Access Compliance Report Public Rights-of-Way (Curb Ramps)

Main Street: ORTEGA_HWY Cross Street: ORTEGA_HWY Location: SW

ADA ID: RPRK211118141115 Ramp Type: Type 1 - Perpendicular Diagonal Initial Pass/Fail: Fail Overall Compliance: No Severity Score: 0

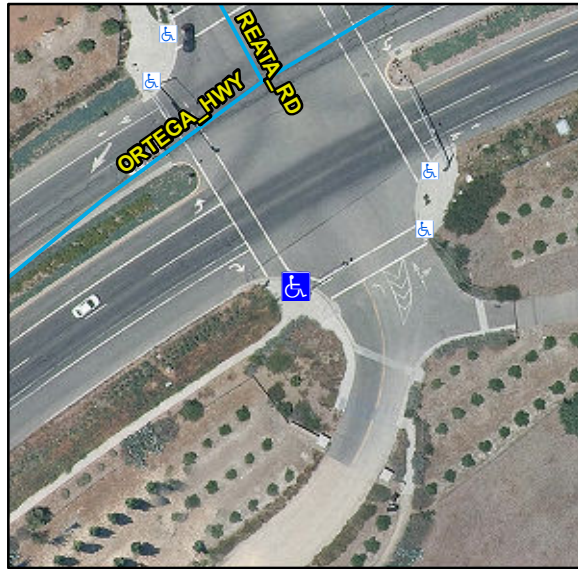
R304.2.2, STD 1115

Remove & Replace Curb Ramp With Two New Directional Ramps or Equivalent. Restripe Crosswalk.
